ADDENDUM 1 COVE CREEK CROSSING REPAIR QUESTIONS AND ANSWERS

Cove Creek National Forest Service Road #809 Crossing to Cove Creek Group Camp Repair Addendum #3

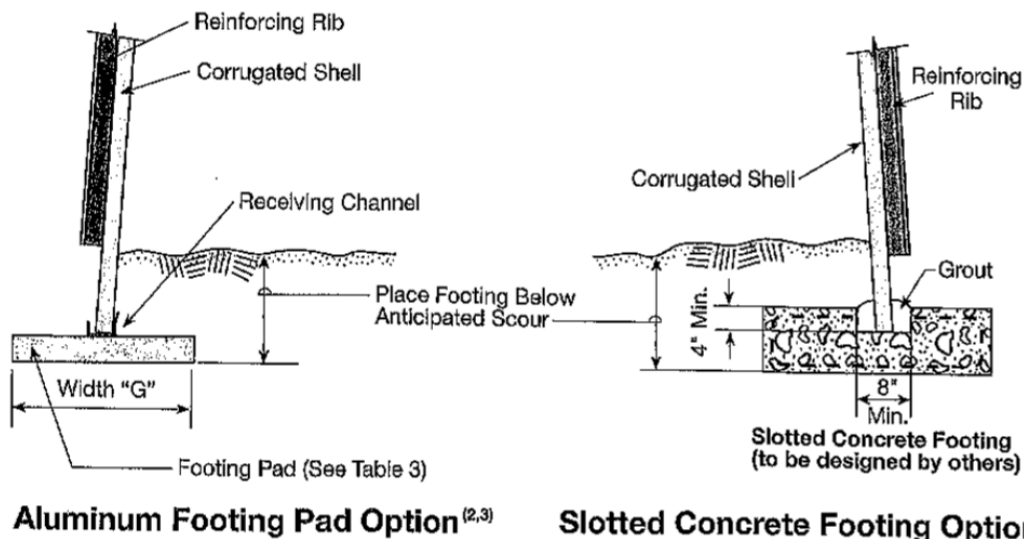
1. Will there be an alternate to Arch Connection to the footers, as per the pre-bid discussion?

“Base Channel Detail” found on sheet #7 of the drawings is replaced with the “Slotted Concrete Footing Option” in the illustration above.
